# Access Compliance Report

## Public Rights-of-Way

### (Curb Ramps)

Intersection ID: 5585	Main Street: MCCULLOUGH_DR	Cross Street: N/A	Location: S
ADA ID: DE247B2EC151	Ramp Type: PerpDiag	Initial Pass/Fail: Fail	Overall Compliance: No
Codes/Mitigation Info/Possible Solution			Severity Score: 30
			Field Measurements/Component Compliance

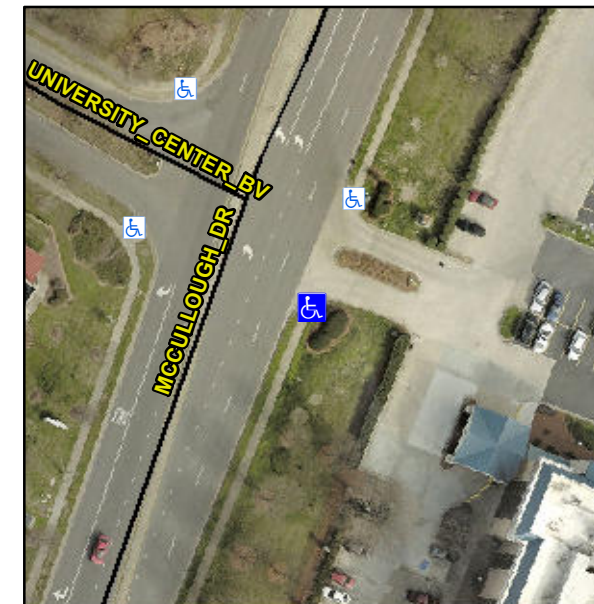
**Not Found, R304.5.1, R304.2.2**

Compliance	Description	Data	Compliance	Description	Data
N/A	Ramp Length (in)	73.0	No	Ramp Slope (%)	9.4
No	Ramp Width (in)	35.5	Yes	Ramp XSlope (%)	1.4
N/A	Flare Type LT	N/A	N/A	Flare Type RT	N/A
N/A	Flare Slope LT (%)	N/A	N/A	Flare Slope RT (%)	N/A
N/A	Flare Traversable LT?	N/A	N/A	Flare Traversable RT?	N/A
N/A	Landing Length (in)	N/A	N/A	DWS Provided?	N/A
N/A	Landing Width (in)	N/A	N/A	DWS Contrast?	N/A
N/A	Landing Slope (%)	N/A	N/A	DWS Length (in)	N/A
N/A	Landing X Slope (%)	N/A	N/A	DWS Full Width?	N/A
N/A	Landing Curb? (Y/N)	N/A	N/A	DWS Offset (in)	N/A
N/A	Shared Landing?	N/A			
N/A	Gutter Ponding?	N/A	N/A	Gutter Slope (%)	N/A
N/A	Gutter Lip Ht (in)	N/A	N/A	Gutter X Slope (%)	N/A
N/A	Painted X Walk1?	No	N/A	Painted X Walk2?	No
	X Walk 1 Direction	To NE		X Walk 2 Direction	To NW
N/A	X Walk 1 Width (in)	N/A	N/A	X Walk 2 Width (in)	N/A
	X Walk 1 Slope (%)	5.0		X Walk 2 Slope (%)	4.0
	X Walk 1 X Slope (%)	3.4		X Walk 2 X Slope (%)	4.2

**Remove & Replace Curb Ramp With Two New Directional Ramps or Equivalent.**
